Access Compliance Report Public Rights-of-Way (Curb Ramps)

Main Street: DAVENPORT_RD Cross Street: BRADBURY_RD Location: NE

ADA ID: RPRK211209133758 Ramp Type: Type 4 - Parallel Initial Pass/Fail: Fail Overall Compliance: No Severity Score: 2

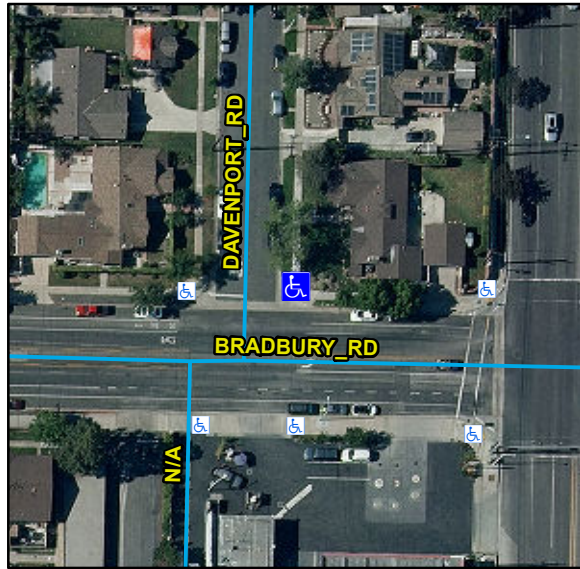
Compliance	Description	Data	Compliance	Description	Data
N/A	Ramp Length LT (in)	128	N/A	Ramp Length RT (in)	128
Yes	Ramp Width LT (in)	100	Yes	Ramp Width RT (in)	89
Yes	Ramp Run Slope LT (%)	5.9	Yes	Ramp Run Slope RT (%)	4.4
No	Ramp Cross Slope LT (%)	2.8	No	Ramp Cross Slope RT (%)	3.2
N/A	Landing Present	N/A	N/A	DWS Provided	N/A
N/A	Landing Length (in)	N/A	N/A	DWS Contrast	N/A
N/A	Landing Width (in)	N/A	N/A	DWS Length (in)	N/A
N/A	Landing Run Slope (%)	N/A	N/A	DWS Full Width	N/A
N/A	Landing Cross Slope (%)	N/A		DWS Offset Type	N/A
N/A	Landing Movement Obstructed?	N/A	N/A	DWS Offset Left (in)	N/A
	Landing Movement Type	N/A	N/A	DWS Offset Right (in)	N/A
N/A	Landing Shared	N/A			
N/A	Clear Space	Yes			
N/A	Clear Space To Crosswalk (in)	N/A			
N/A	Marked Crosswalk 1	No	N/A	Marked Crosswalk 2	No
	Crossing 1 Direction	W		Crossing 2 Direction	S
	Marked Crosswalk 1 Width (in)	N/A		Marked Crosswalk 2 Width (in)	N/A

Remove & Replace Curb Ramp With Two New Directional Ramps or Equivalent.
